V3 - SDP-23-04

EROSION CONTROL PLAN - PH. 1
7ELEVEN AT WALLBROOK (LOT 11)
Town of Rolesville Project No. SDP 23-04
US 401 Business / S. Main Street & Virginia Water Drive
Wake Forest Township, Town of Rolesville, Wake County, North Carolina

Town of Rolesville Project No. SDP 23-04

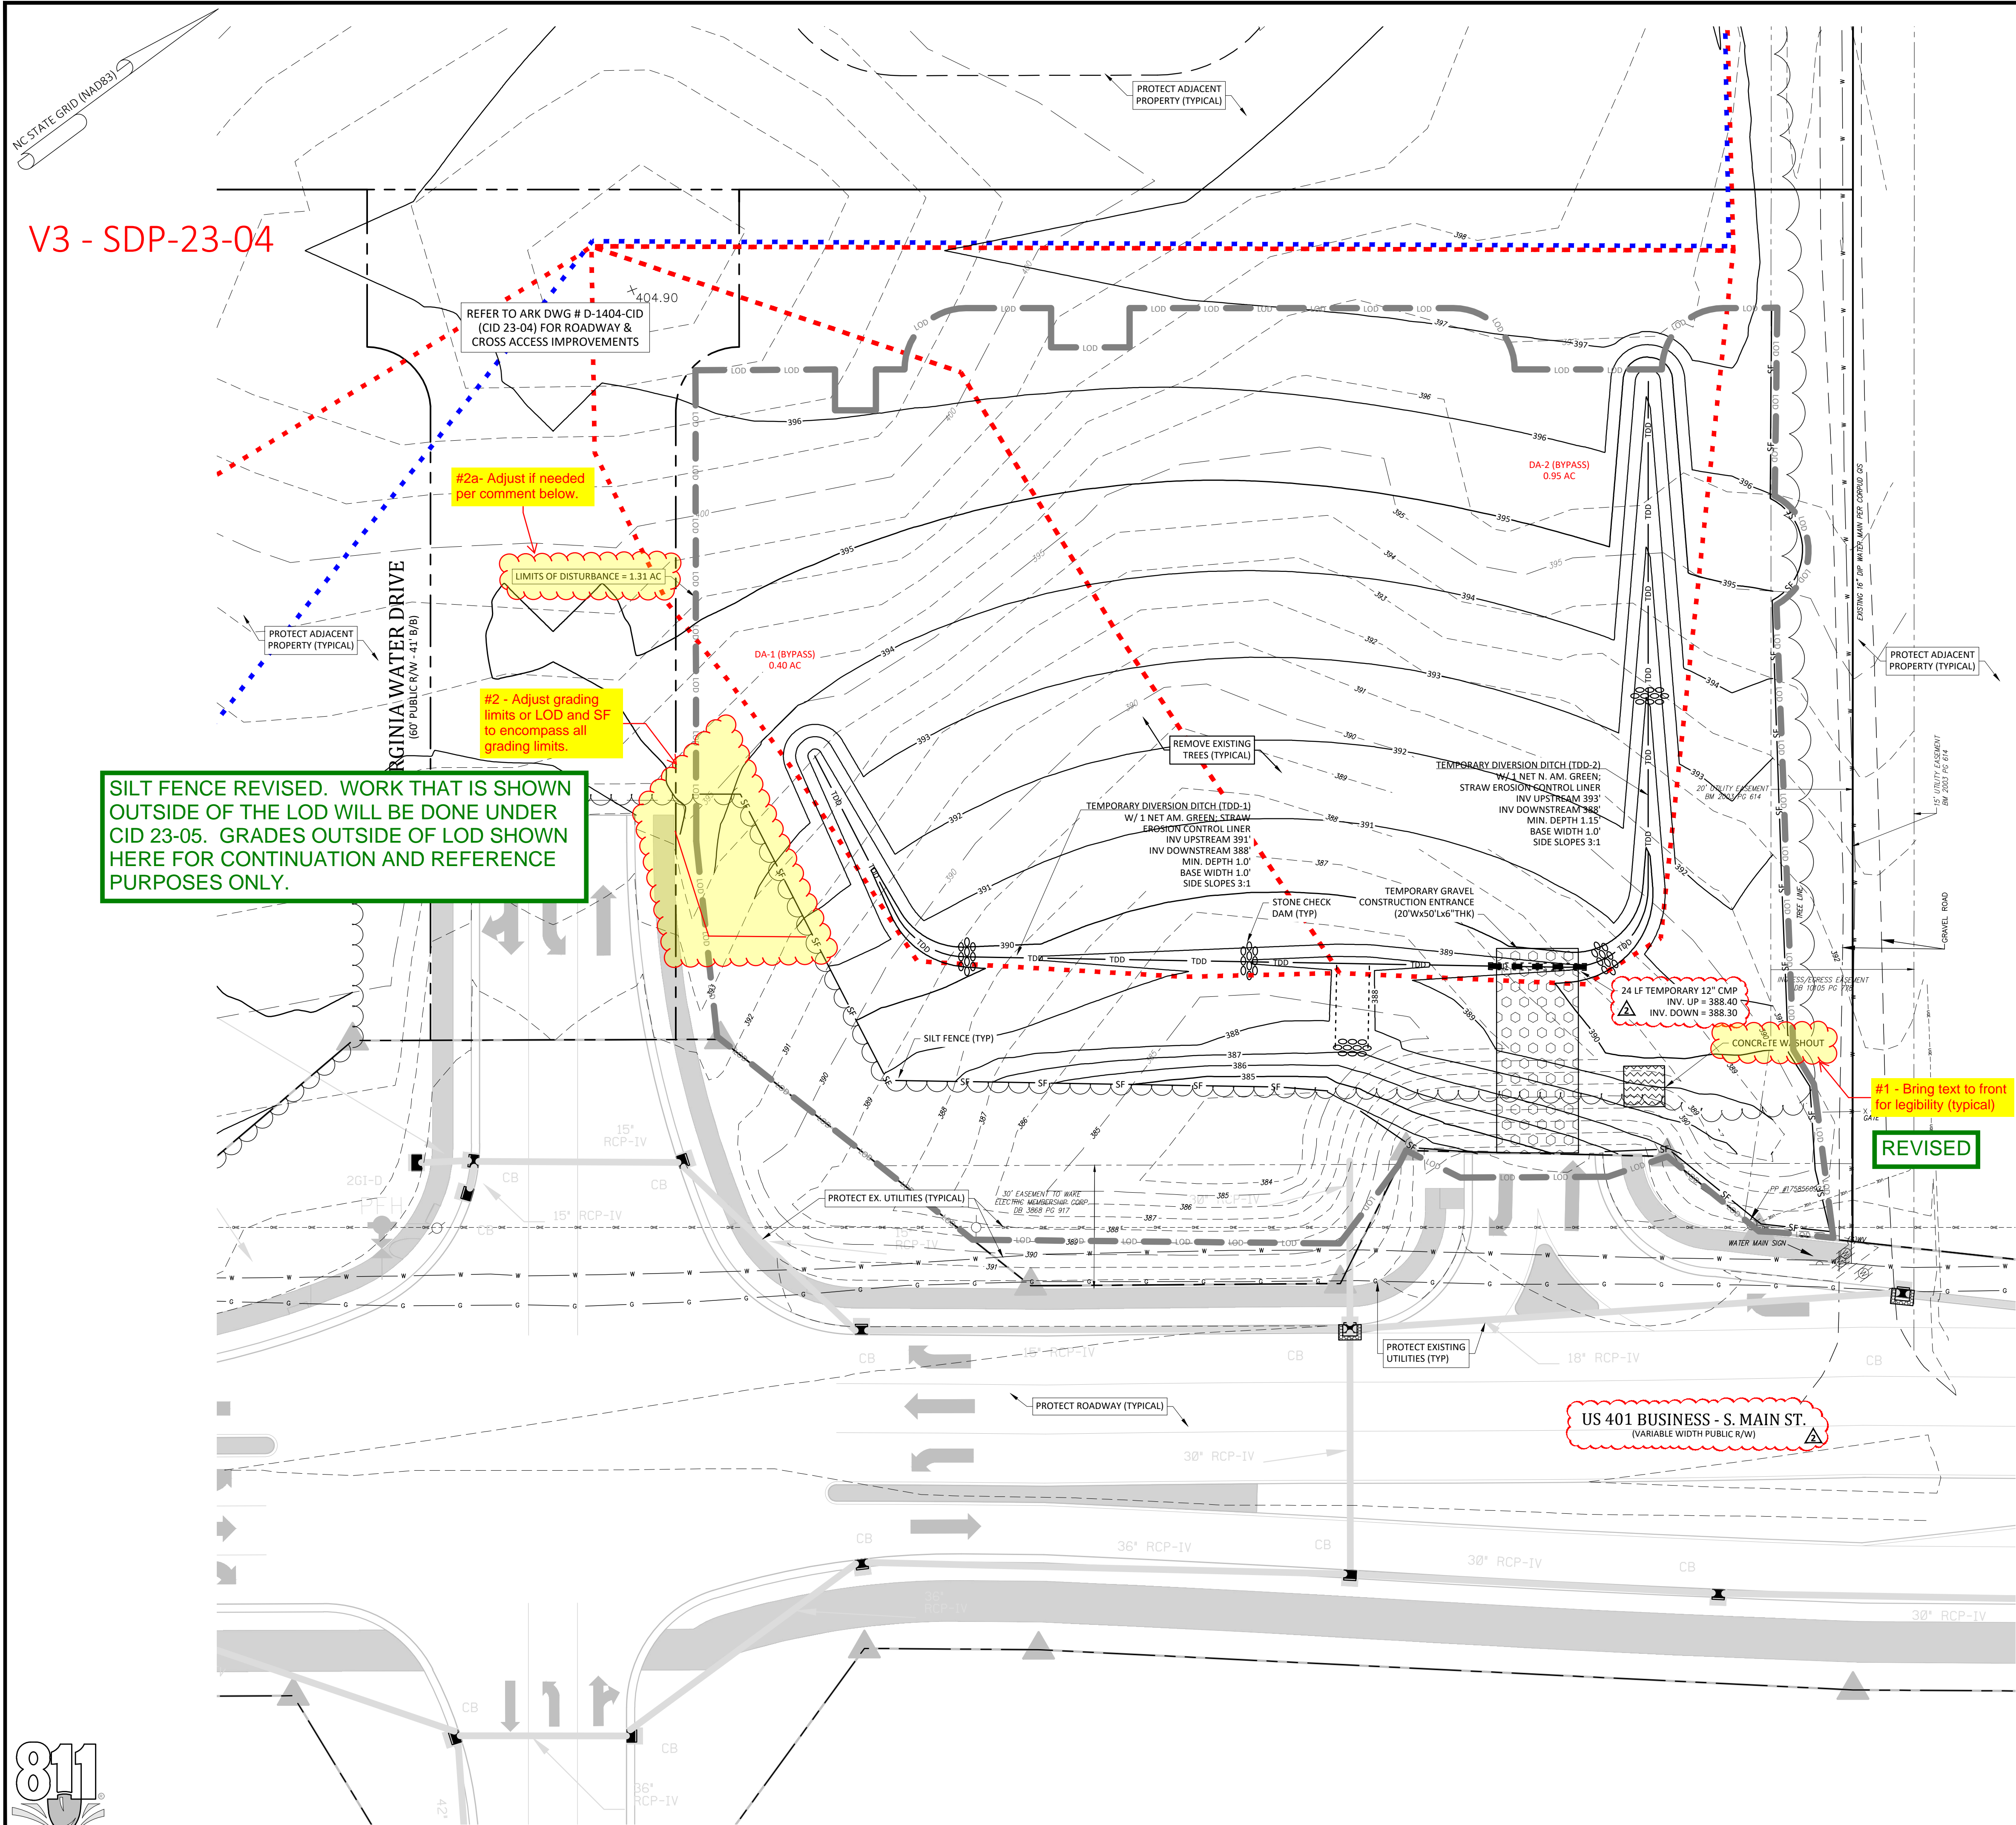
#2a- Adjust if needed per comment below.

#2 - Adjust grading limits or LOD and SF to encompass all grading limits.

#1 - Bring text to front for legibility (typical)

SILT FENCE REVISED. WORK THAT IS SHOWN OUTSIDE OF THE LOD WILL BE DONE UNDER CID 23-05. GRADES OUTSIDE OF LOD SHOWN HERE FOR CONTINUATION AND REFERENCE PURPOSES ONLY.

REVISED
